DEVELOPMENT REVIEW BOARD - **HYDROLOGY SECTION**

DRB Project Number: 2021-006297 Hearing Date: **5-18-2022**

Project: Tracts 469 & 470 Lands of Atrisco Land Grant-7300 Santa Barbara Agenda Item No: **11**

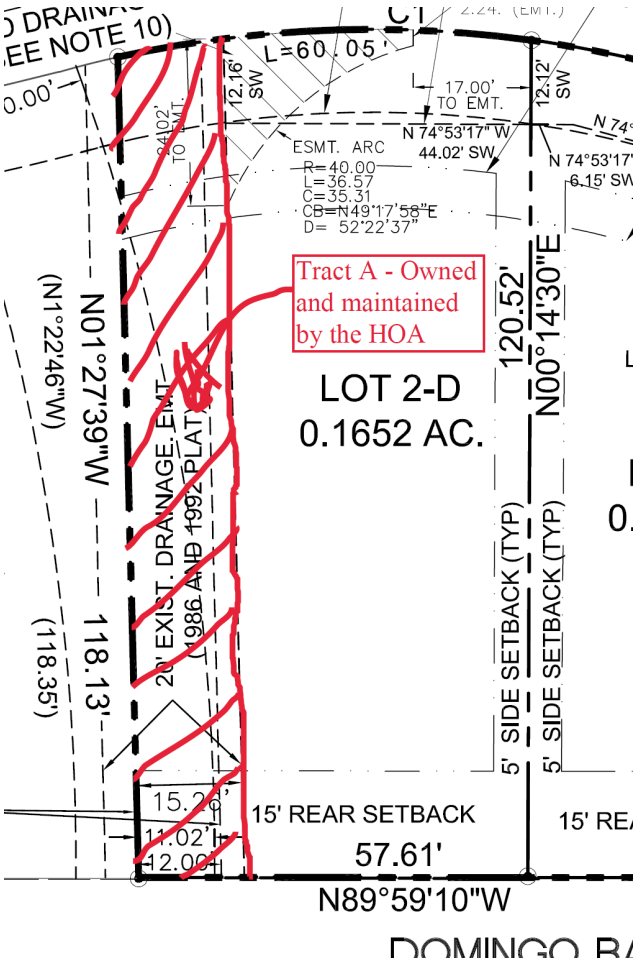
- Hydrology sent a comment letter (D19D001F) on May 09, 2022.
- The existing drainage easement shown as part of Lot 2-D should be on its own tract to be owned and maintained by the HOA.

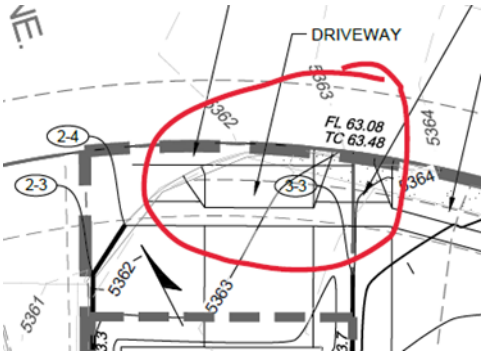
- Typically, the drive pad cannot be built on a radius. Please consult Transportation Section.

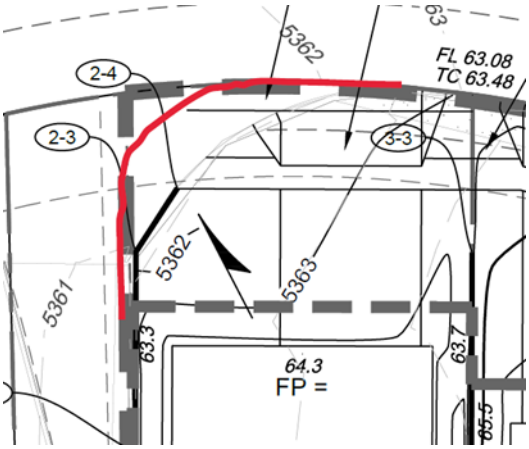
This problem can be solved with extending the curb & gutter along the property line and then have a smaller radius after the drive pad as shown below.

Then the Drainage Easement on the Plat can be reduced.
